STAFF REPORT: 10/08/2025 REGULAR MEETING

APPLICATION NUMBER: HDC2025-00561

ADDRESS: 14635 E. JEFFERSON

SCOPE: ALTER AND REHABILITATE BUILDING, CONSTRUCT NEW PARKING LOT

Drawing from current application

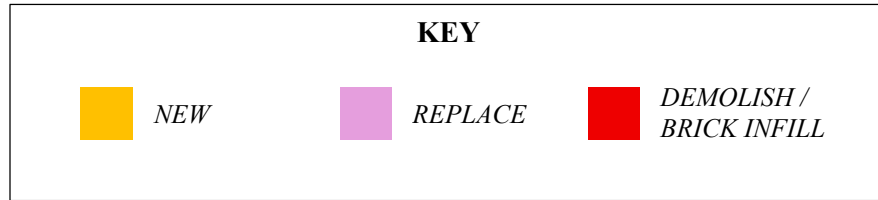
- The existing storefront panels, with their flat surface and lack of details, appear to reflect a more modern design, contrasting with the ornamental details, like panels, typical of historic storefronts of that era.

- The historic wood door at E. Jefferson is a distinctive, character-defining feature of the property that has not been proven to be beyond repair.
- The proposal is missing the design, material, and specifications for the storefront system panels, the material for the gate, the type and color of mortar to be used for any repointing, and the infill brick specifications.

- The proposed storefront system panel design, materials, and specifications shall be provided to staff for review and approval.
- The proposed material for the gate shall be provided to staff for review and approval.
- The existing historic door at the E. Jefferson Avenue entrance shall be restored, and not painted, instead of replaced.
- A historic mortar mix shall be used for the proposed repointing, as the mortar must be softer than the historic brick and match the composition of the existing historic mortar.
- A photo of the sample of the infill brick next to the existing historic brick shall be provided to staff for review and approval to ensure that it is suitable for exterior use and is compatible in texture, color, and dimension with the adjacent historic brick.

Drawings from application

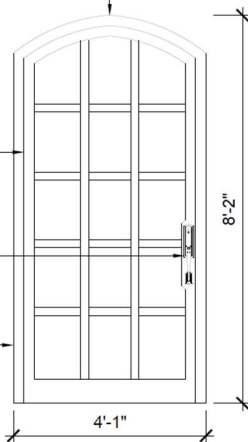
- The existing, historic wood door is a distinctive, character-defining feature and has not been proven to be beyond repair.

- The applicant proposes to replace the door with a replica wood door and paint it B6: Moderate Brown.

Materials from applicant

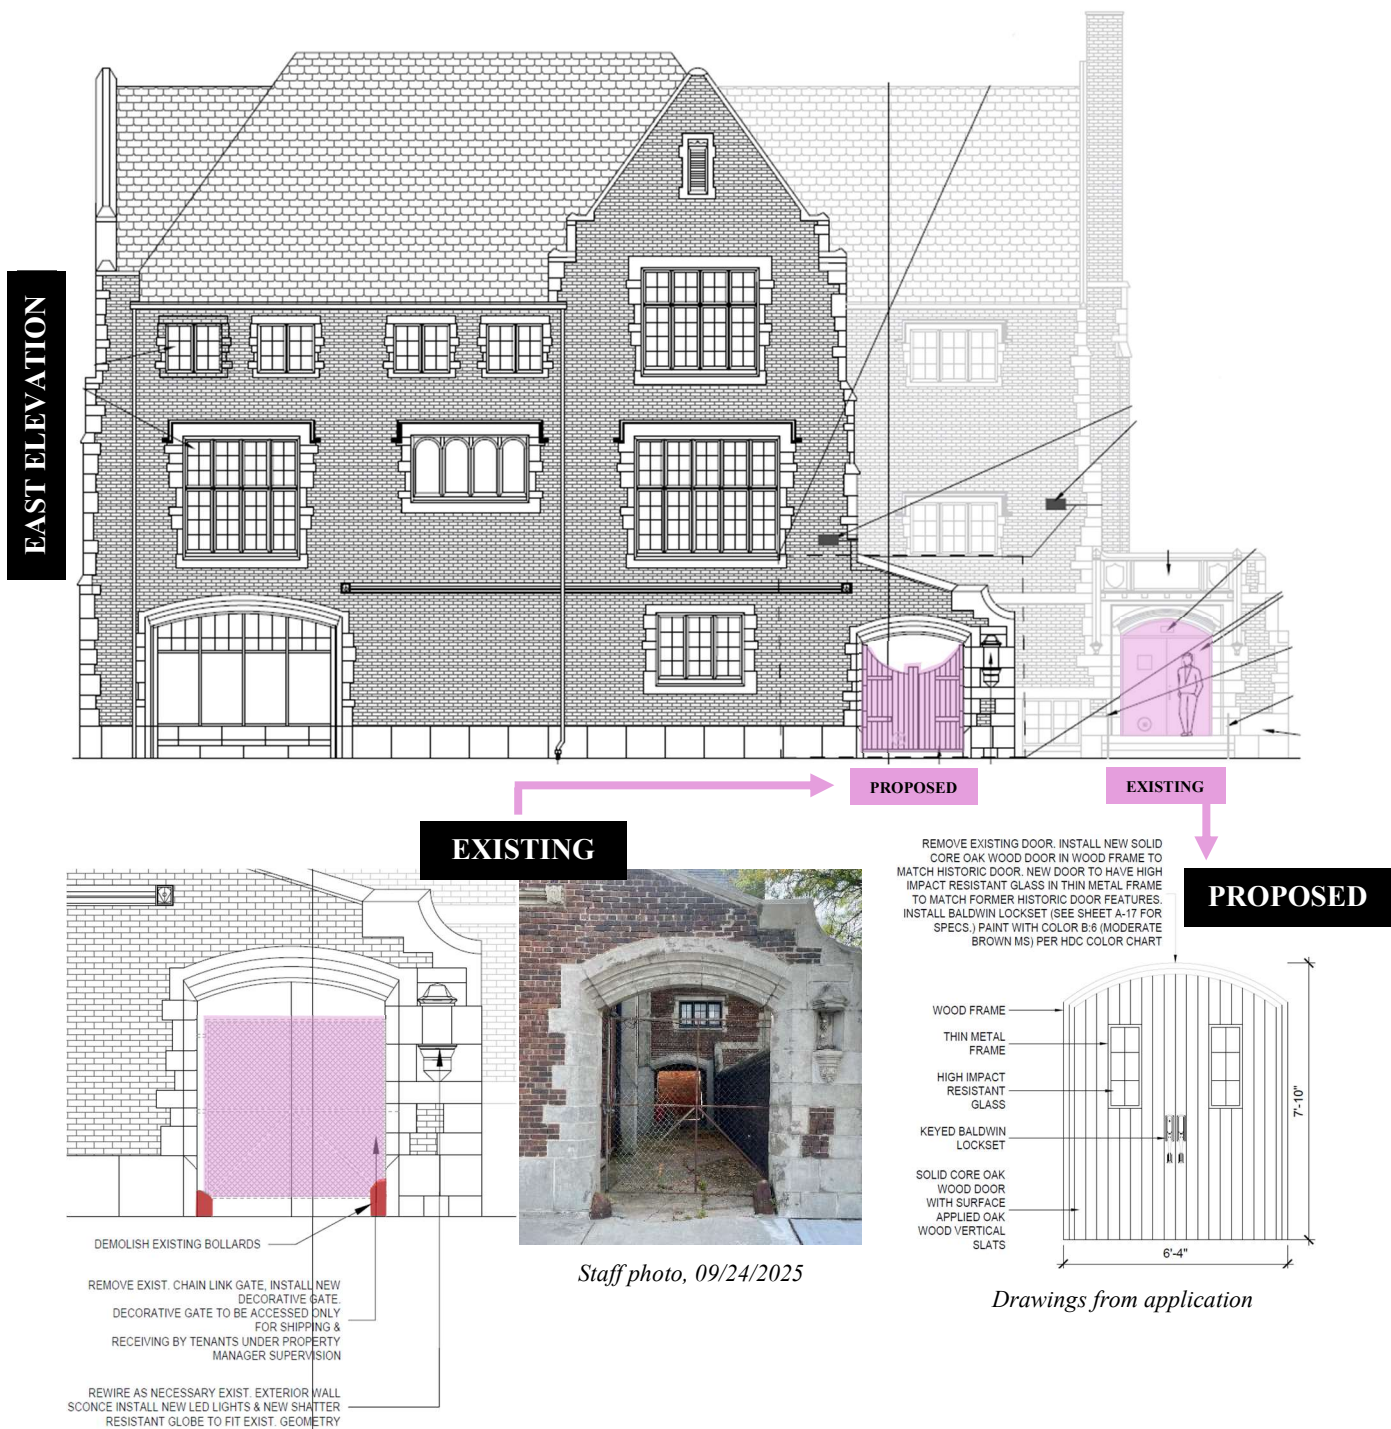
- The application proposes to install skylights at the south roof surface, facing E. Jefferson. The submitted materials for the product indicate that the skylights will be steel, fixed, and flush mounted. Although we do not have the measurements of the proposed skylights, the applicant is seeking to install three groupings of skylights, which will extend nearly the full length of the south roof surface. When viewed from the public right-of-way, especially from E. Jefferson, the proposed skylights will present as a highly visible modern intrusion that is not compatible with the building's historic character. Considering this building is on the corner, staff does not recommend the installation of skylights on any of the sloped roof surfaces, as they will be visible from the public right-of-way.

- The installation of the proposed skylights does not follow NPS guidelines. Specifically:
 - *Illustrated Guidelines on Sustainability for Rehabilitating Historic Buildings*

- The installation of the skylights is inappropriate, especially given the distinctive materiality and high public right-of-way visibility of the slate roof. The Secretary of the Interior's Standards for Rehabilitation (quoted in full below) require that historic materials and distinctive features be retained. Additionally, the NPS' guidelines state that "Adding skylights or dormers on primary or highly-visible roof elevations where they will negatively impact the building's historic character." and "Buildings that have prominent roofs or highly visible roof elevations are usually not good candidates for skylights."

- The new skylights will be highly visible from the public right-of-way as they will extend nearly the full length of the south roof's surface and will diminish the historic building's character.

- The NPS' guidelines state that "Adding skylights or dormers on primary or highly-visible roof elevations where they will negatively impact the building's historic character." and "Buildings that have prominent roofs or highly visible roof elevations are usually not good candidates for skylights."

Recommendation 1 of 2 – Denial – Install skylights

Drawings from application

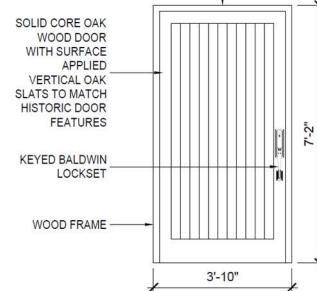
- This corridor is partially visible from the public right-of-way with the existing chain-link gate. With the applicant's proposed gate (see previous page), this corridor would not be visible from the public right-of-way. Considering its rear location and proposed privacy gate, it is staff's opinion that the alterations to the existing openings are appropriate because the current doors and windows do not reflect the overall design features which distinguish this building regarding detailing and instead present a more utilitarian appearance than the character-defining doors and windows which are present at the building's façade and other sides.

Proposed new trash enclosure, plan

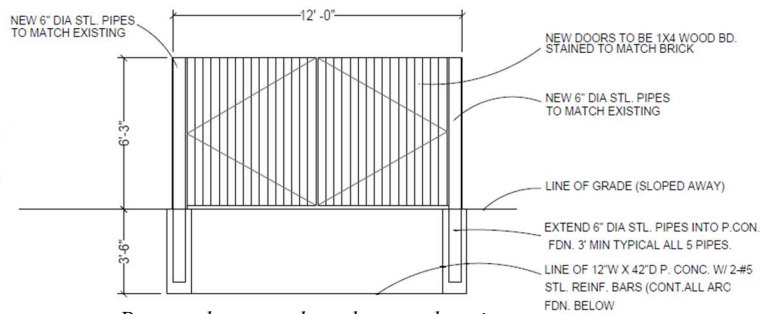
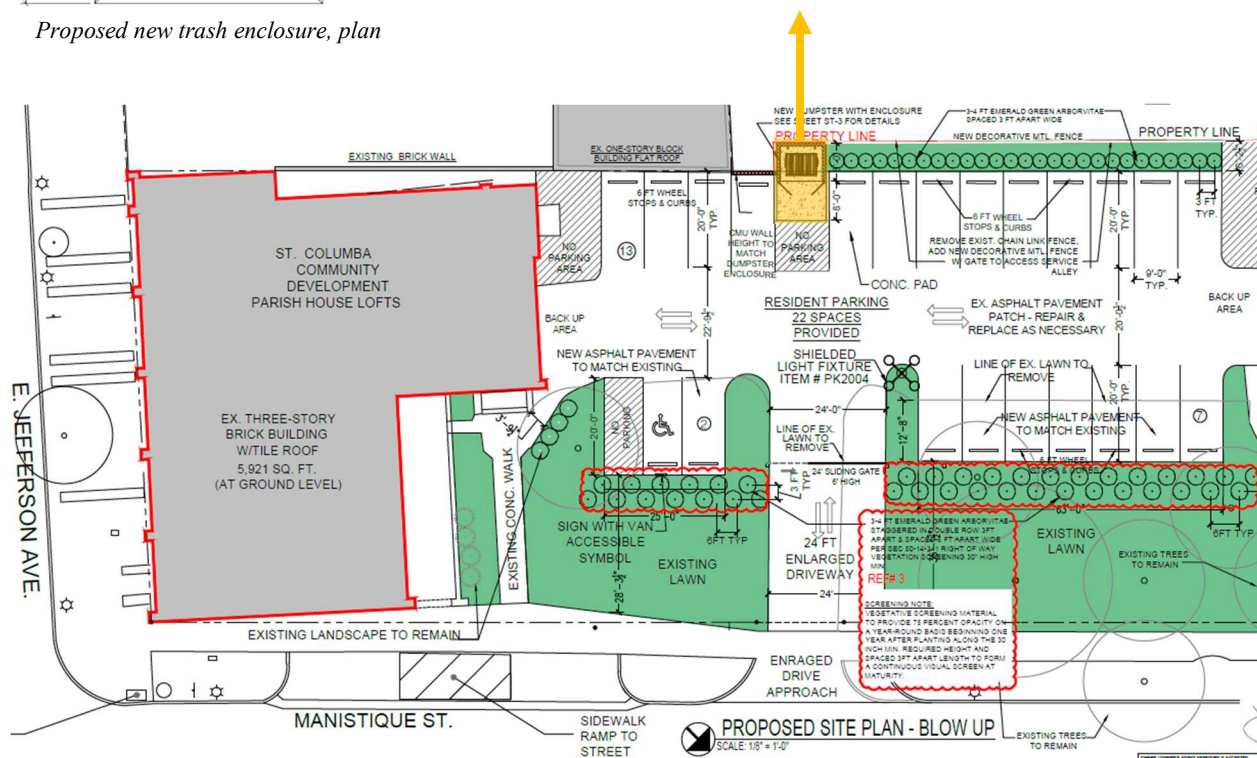
- Staff does not have the authority to approve the construction of new trash enclosures requesting foundations. Therefore, this portion of the project has been submitted to the Commission for review and approval via the current application.

It is staff's opinion that the proposed parking lot and trash enclosure does meet the NPS Secretary of the Interior's Standards for Rehabilitation with respect to new additions, specifically Standard #9:
